Model: Bellini-C2 Finisher (SR841)

Modified Article: Pawl Stopper Open And Close Bracket

Modification Bulletin

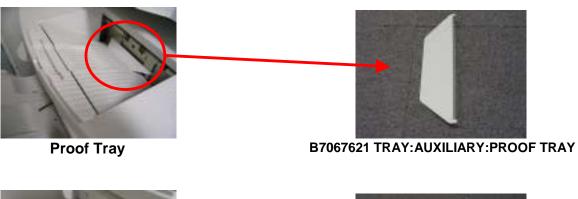
Change: Parts added. **Reason:** To improve paper stack accuracy for Z-fold paper.

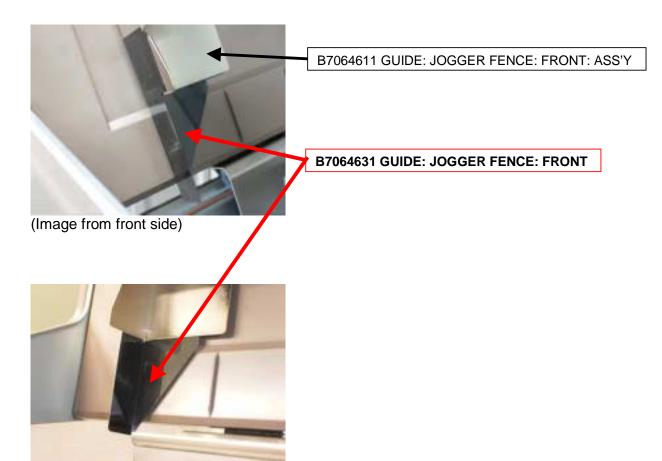
Change: Guide added, assembly P/N changed. **Reason:** To further improve the accuracy of the jogger fence.
